# UNITED STATES PATENT AND TRADEMARK OFFICE

10/690,965

**Office Action Summary**

U.S. Patent Feb. 26, 1991 Sheet 1 of 1 4,996,416

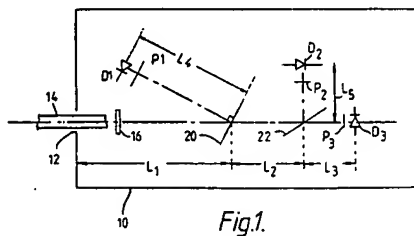
Matthews discloses all of features of claimed invention except for the optical path from an aperture to the first face type photodetector and second face type photodetector. However, Chaney teaches that it is known in the art to provide optical detection device comprising the optical path from an aperture (12 of figure 1) to a beam splitter (22 of figure 1) and first detector (D3 of figure 1, i.e.,  $L_1 + L_2 + L_3$ ) and second detector (D2 of figure 1, i.e.,  $L_1 + L_2 + L_5$ ). See figures 1-2.

U.S. Patent Jul. 23, 2002 Sheet 3 of 7 US 6,424,412 B1

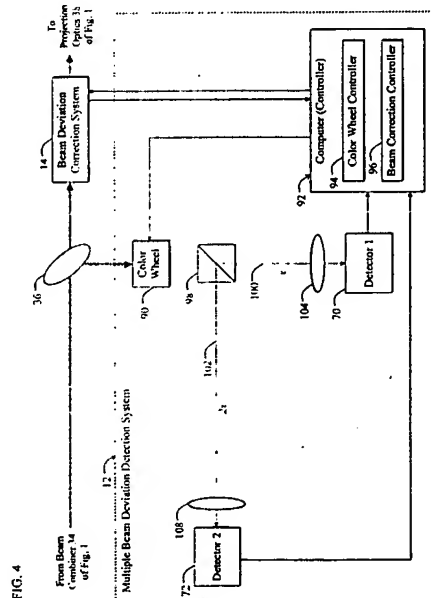
an optical path separation element (considered to be a beam splitter [98 of figure 4) to which a parallel laser beam(34 of figure 4 and col.9 lines 3-6, 9-13, and 24-35) is made incident through a beam pick-off device (36 of figure 4, see abstract such as a pick-off collimating lens or beam splitter);

a first face-type photo-detector (70 of figure 1) that receives the laser beam transmitted (100 of figure 4) through the optical path separation element (98 of figure 4);  
and

a second face-type photo-detector (72 of figure 4) that receives the laser beam reflected (102 of figure 4) by the optical path separation element (98 of figure 4),

wherein a length of an optical path from the beam pick-off device to the first face-type photo-detector (predetermined distance from the beam pick-off device [36 of figure 4] to a beam splitter [98 of figure 4] + x distance from beam splitter [98 of figure 4] to first detector [70 of figure 4]) is set to be different (x distance is different from 2x

distance, see col. Col.8 lines 60-65) from a length of an optical path from the beam pick-off device to the second face-type photo-detector (predetermined distance from the beam pick-off device [36 of figure 4] to a beam splitter [98 of figure 4] + 2x distance from beam splitter [98 of figure 4] to second detector [72 of figure 4]). See figures 1-8.
